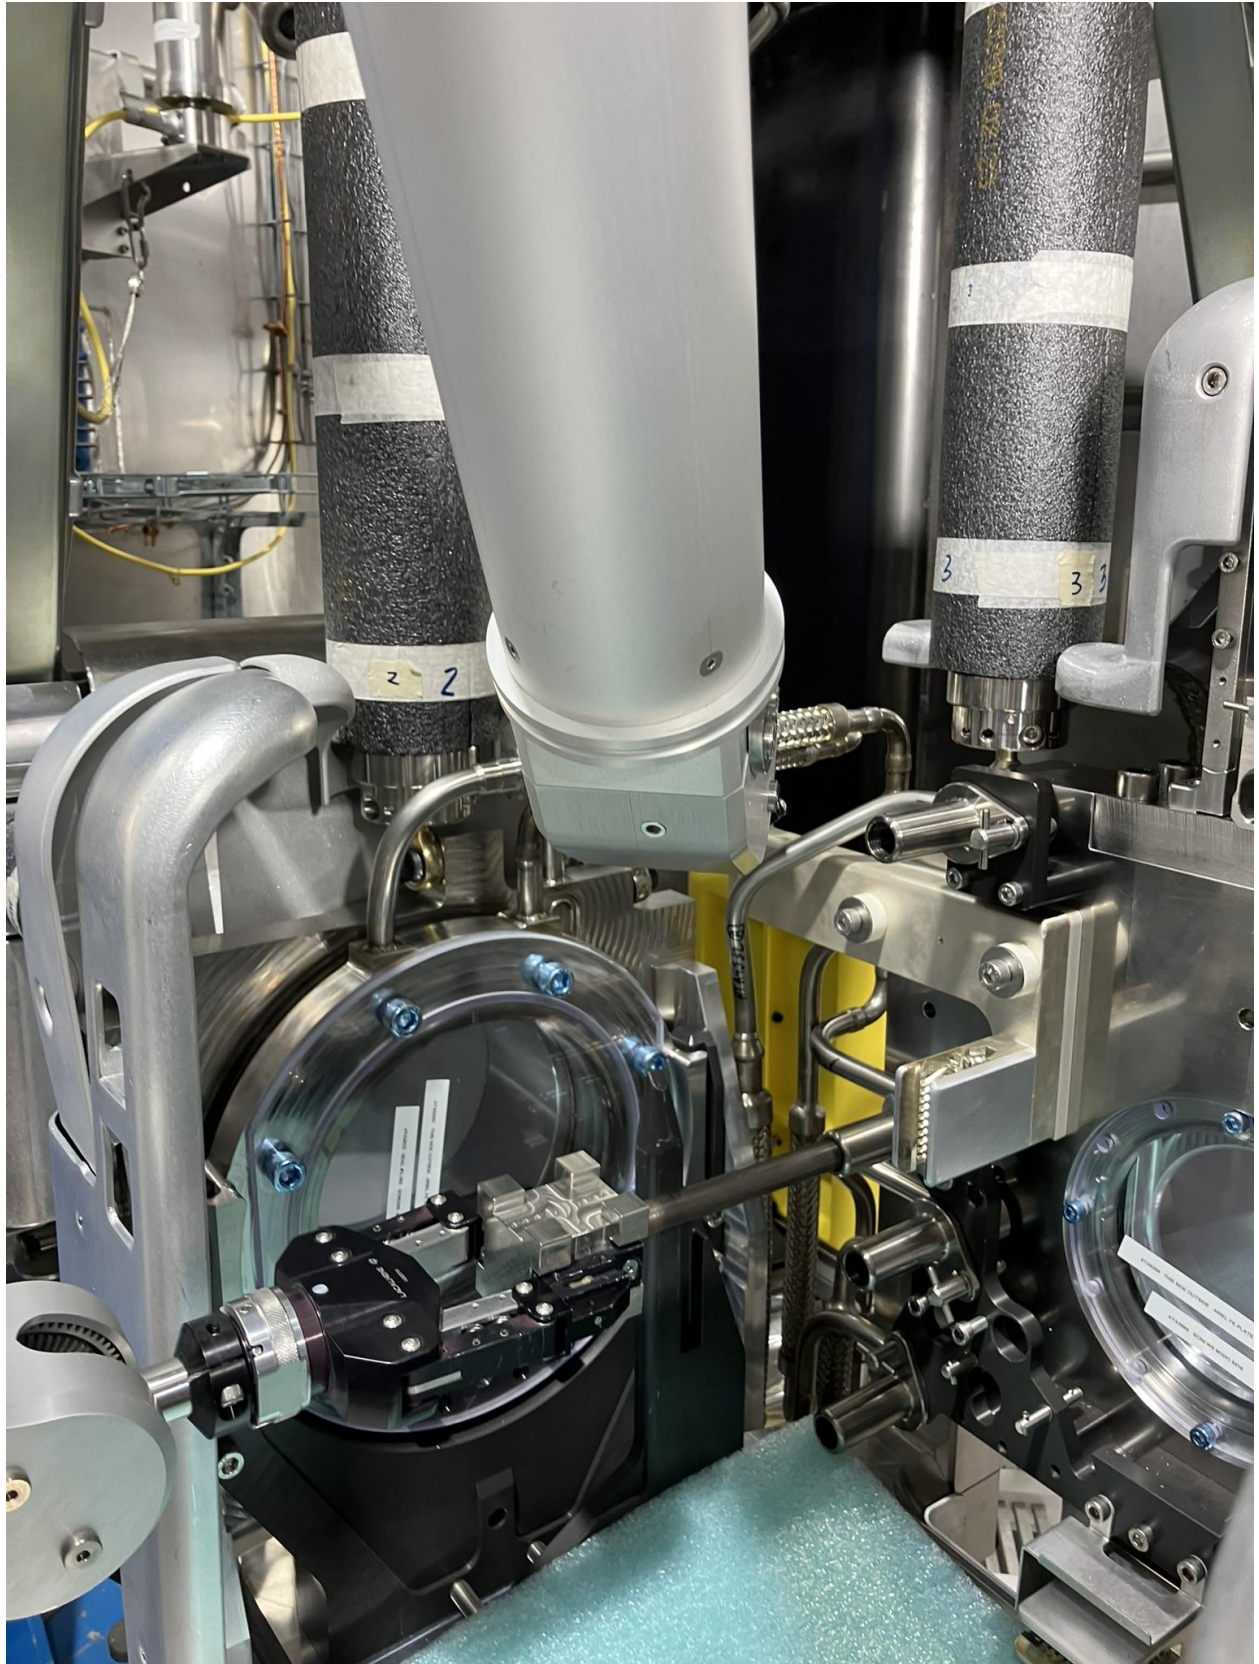
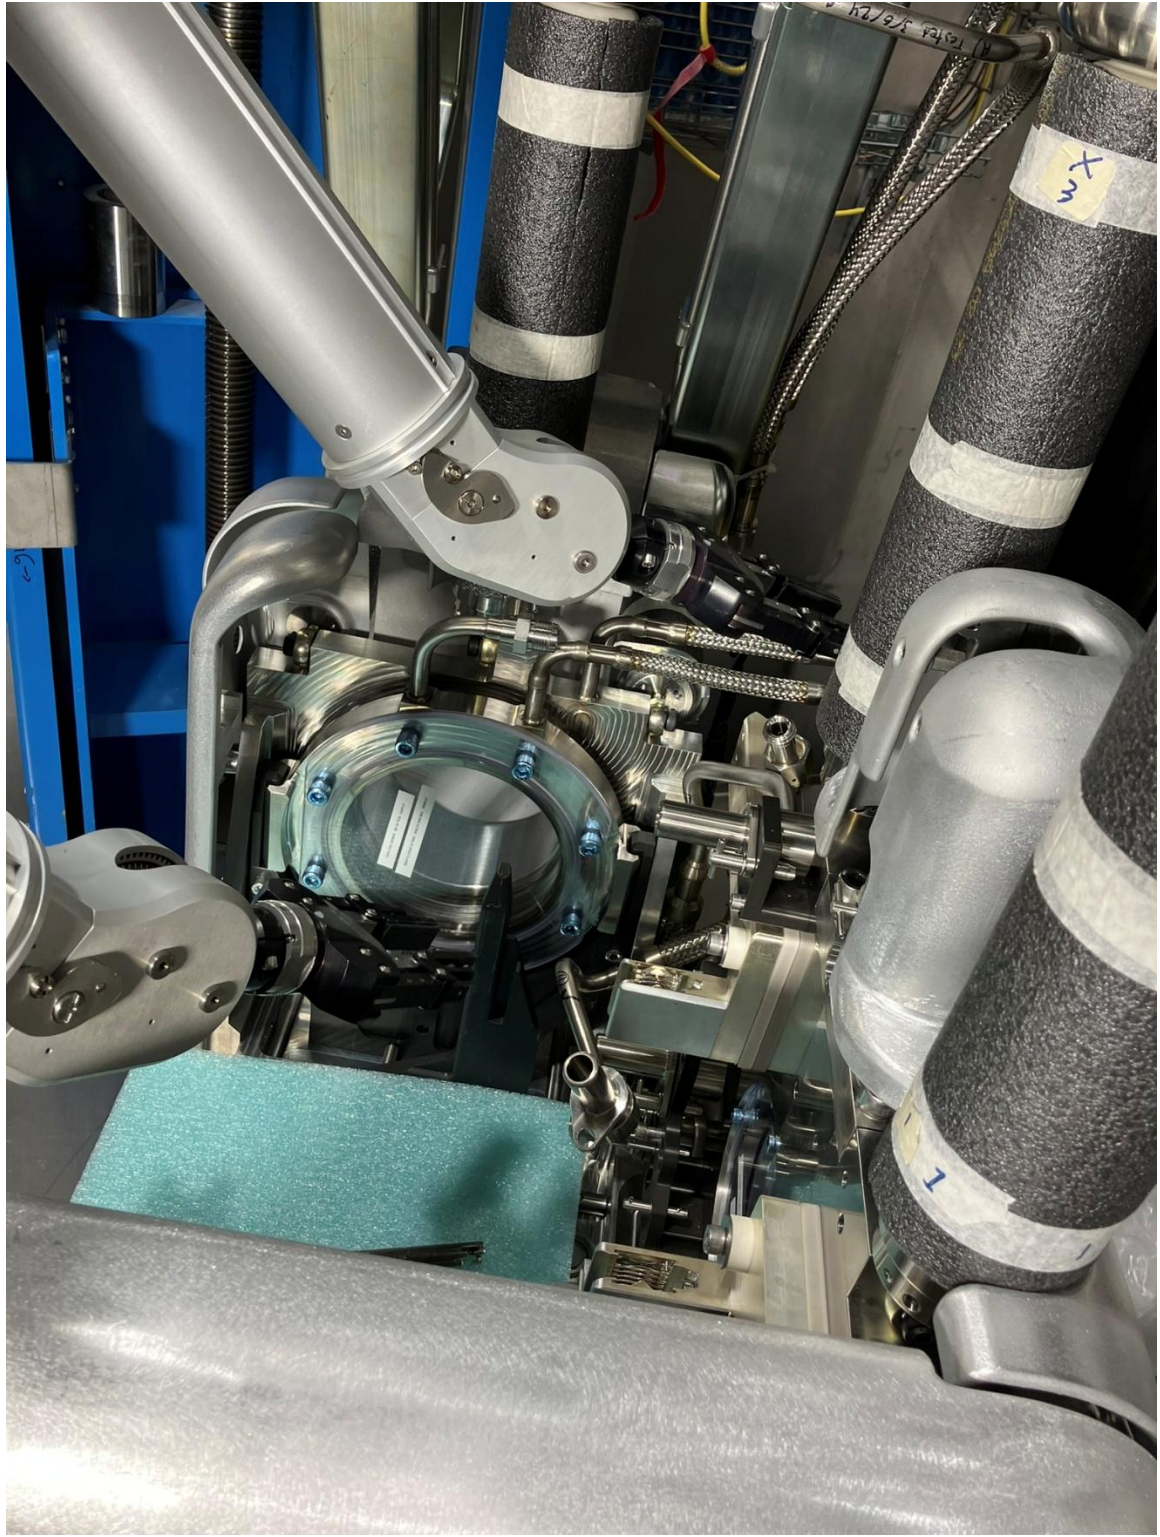
Pin tool interfering with HTV post when using for the second to top line.

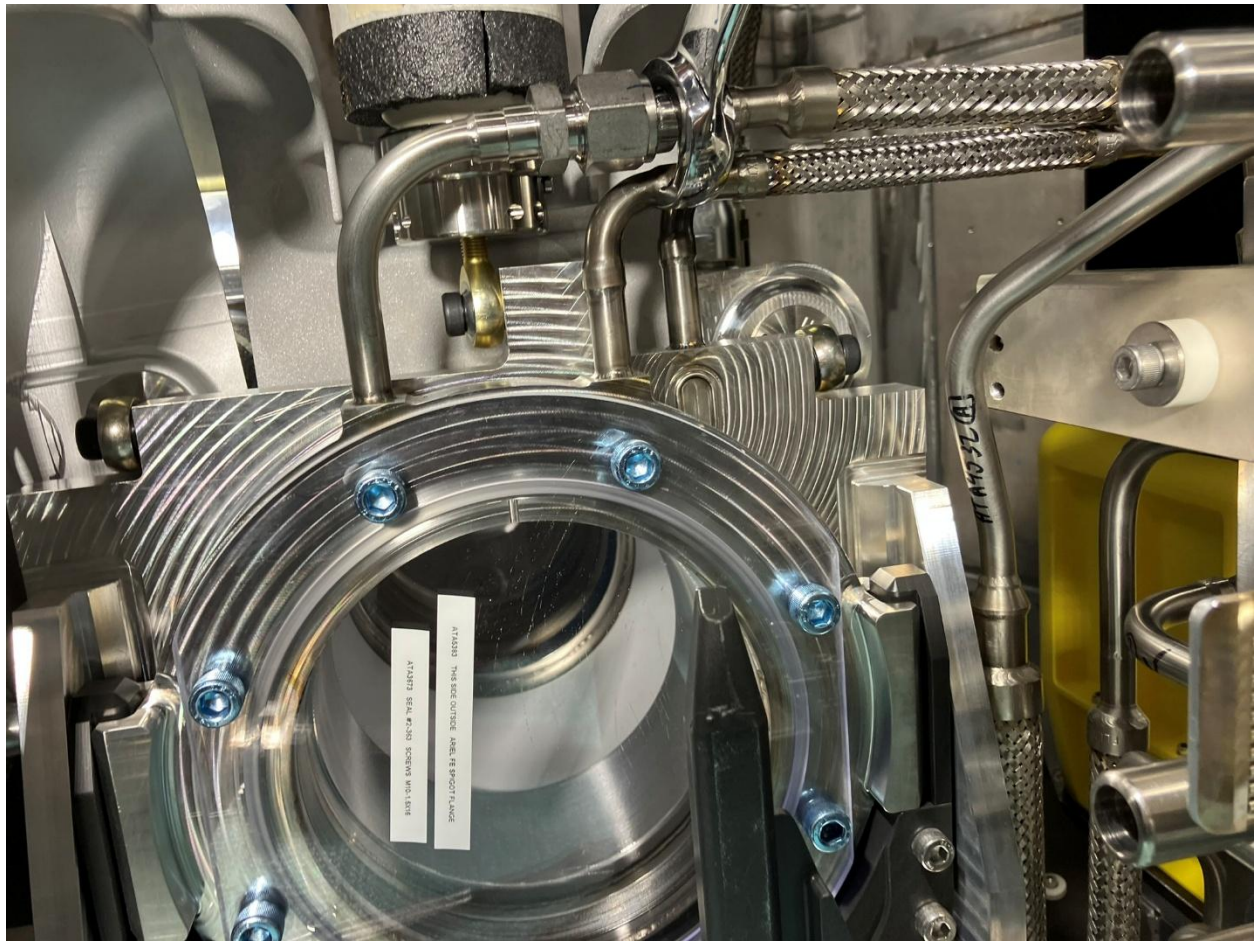
Starting VCR joint on second to top line with difficulty

Wrench interference with adjacent line in second to top line's VCR joint

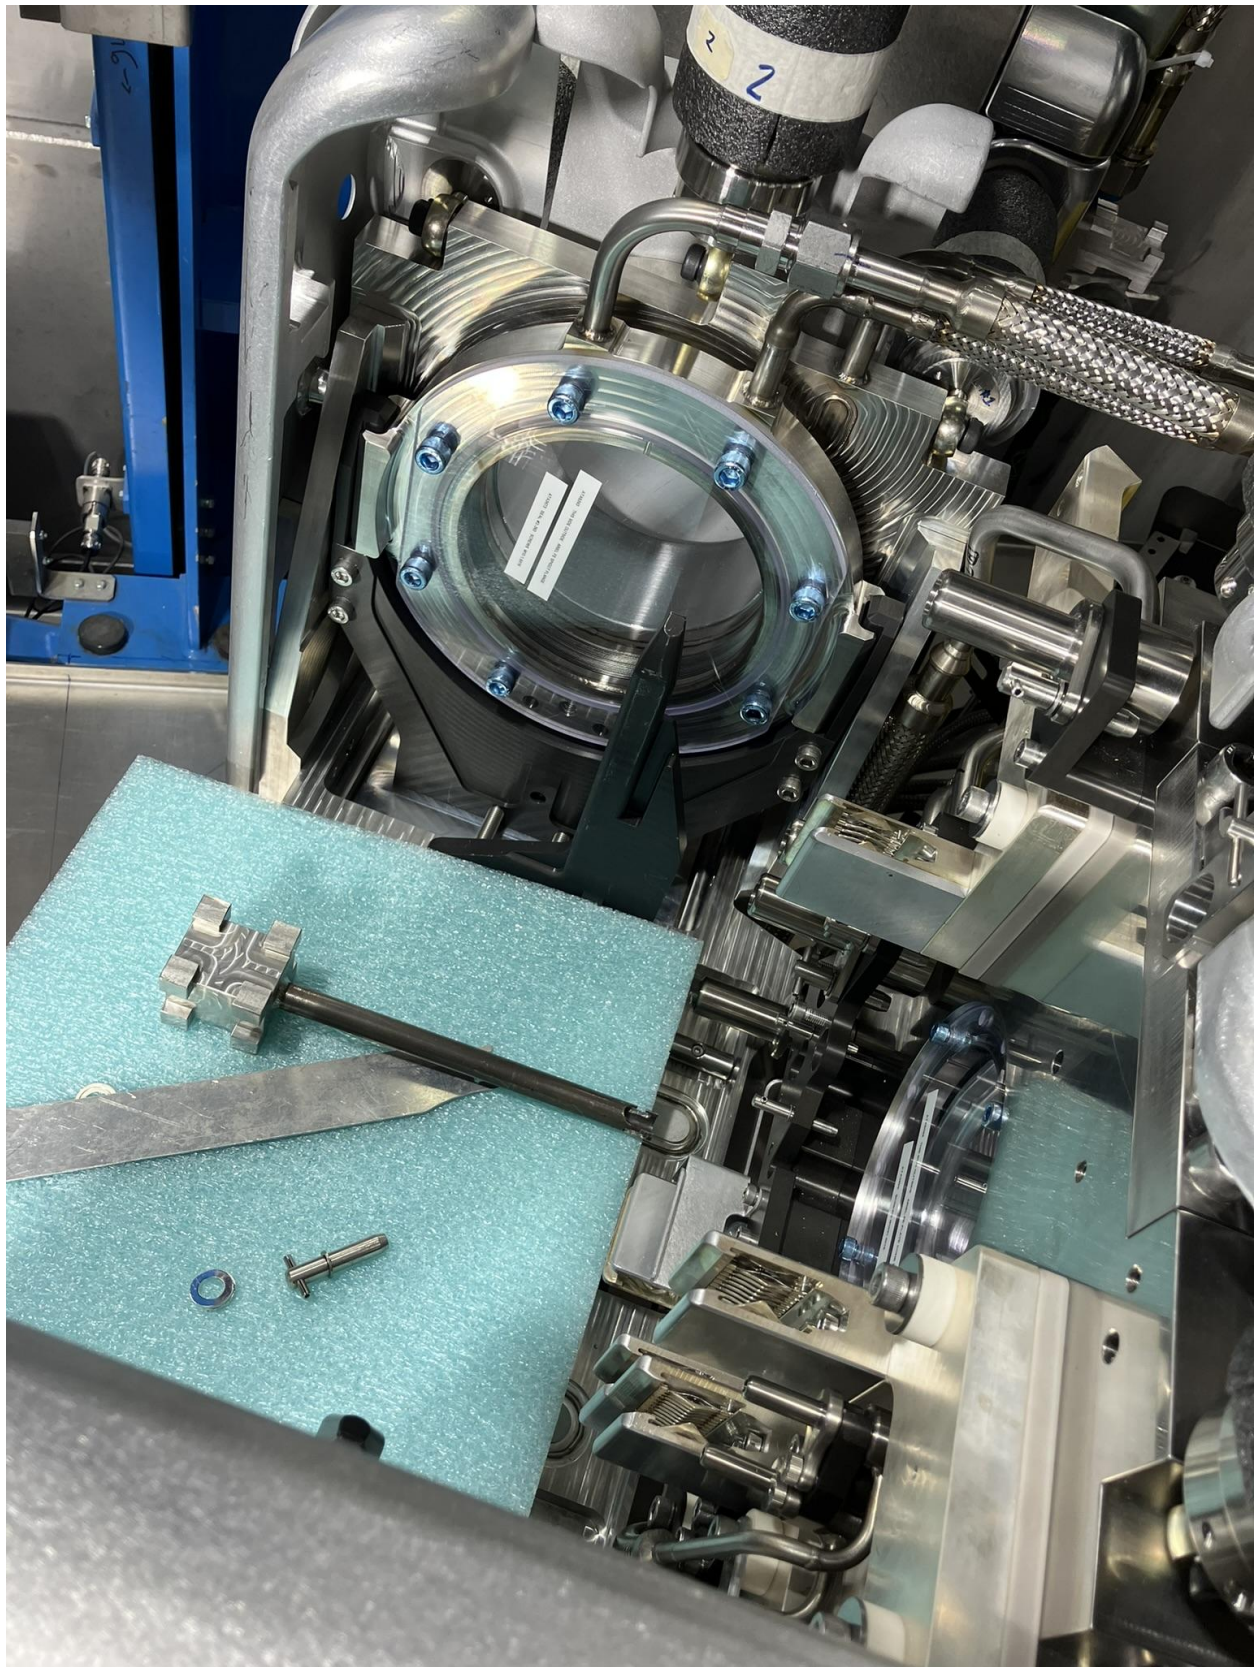
Nut falling in top line's VCR joint 'U' bend.

Bottom line catching on screws when returned/removed.
